High-Strength Bolts for Bridges

Report No. FHWA-SA-91-031

Addendum

(date of Addendum: April 14, 1994)

Fig. 19

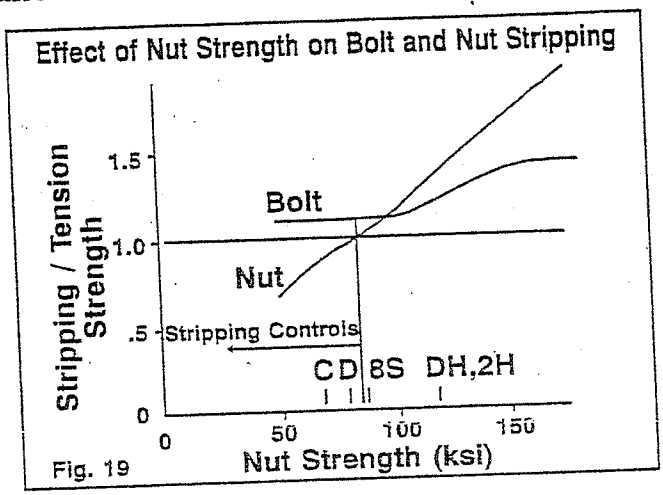
3-26 Alexander's model:

2 - 13

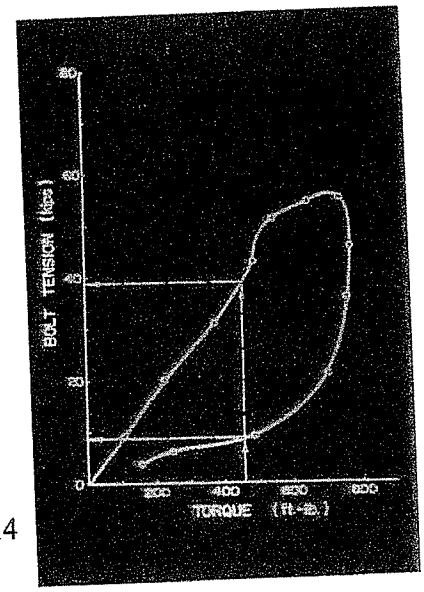
2-13

Matching Nuts

A325/M164	A563/M291	A194/M292
Type 1 & 2	C,C3,D,DH,DH3	2,2H
Type 1 Galv.	DH	2H
